MAINTENANCE Mi11-26B **INFORMATION**

SUBJECT: IMPORTANT PRECAUTIONS TO BE TAKEN

WHEN INSTALLING SUBSTITUTE FAN CLUTCH

550965 & 550966

1.0 **INSTALLATION OF THE EARLY VERSION OF FAN CLUTCH 550966**

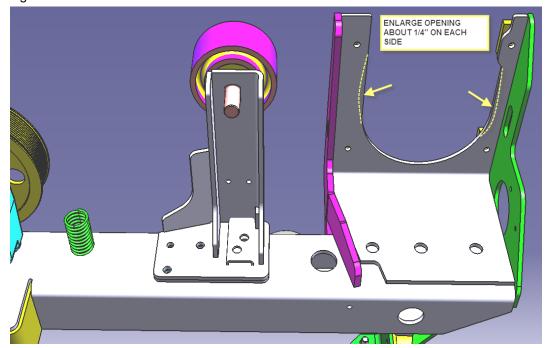
- 1. A modification may be necessary when installing the early version of fan clutch 550966 (already sold out substitute for Linnig 550839). The opening on the mounting support might be too narrow, preventing the fan clutch from turning.
- 2. In order to install the early model of fan clutch 550966, the mounting support opening must be enlarged 1/4" on each side.

2.0 CHECKING THE GAP BETWEEN THE FAN CLUTCH AND THE RADIATOR

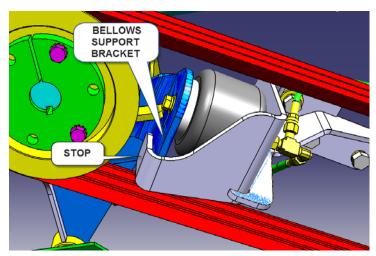
- 1. Once the new fan clutch installation is completed, perform the following steps prior to reinstall the belts.
- Tilt the fan driving mechanism support toward the radiator until the bellows support bracket leans against the stop.
- 3. Make sure that a gap remains between the fan/clutch and the radiator core (or reinforcement rods if present). This gap will prevent damages to the radiator and fan clutch in case of breaking of the drive belts. Moreover, the fan produces a rapid increase of thrust when 2nd speed engages. This force tends to bring the fan clutch closer to the radiator.

4. If no gap remains or if the gap is too short, you must perform the following corrective measures:

2.1 MOVING THE COOLING PACK

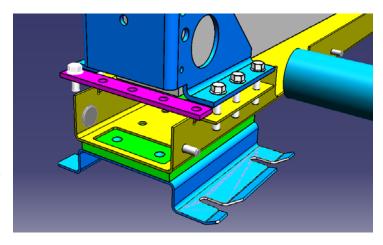
a) To increase the gap, make sure that the cooling pack is as far as possible from the fan driving mechanism. If the cooling pack has already been removed in the past, there is a chance that it hasn't been reinstalled at the most distant position. Use the slots at the base of the cooling pack to gain space.

MOVING THE COOLING PACK SHOULD BE ENOUGH TO GET AN APPROPRIATE GAP. IF THIS IS NOT THE CASE, MOVE THE FAN DRIVING MECHANISM SUPPORT AS PER THE FOLLOWING PROCEDURE.
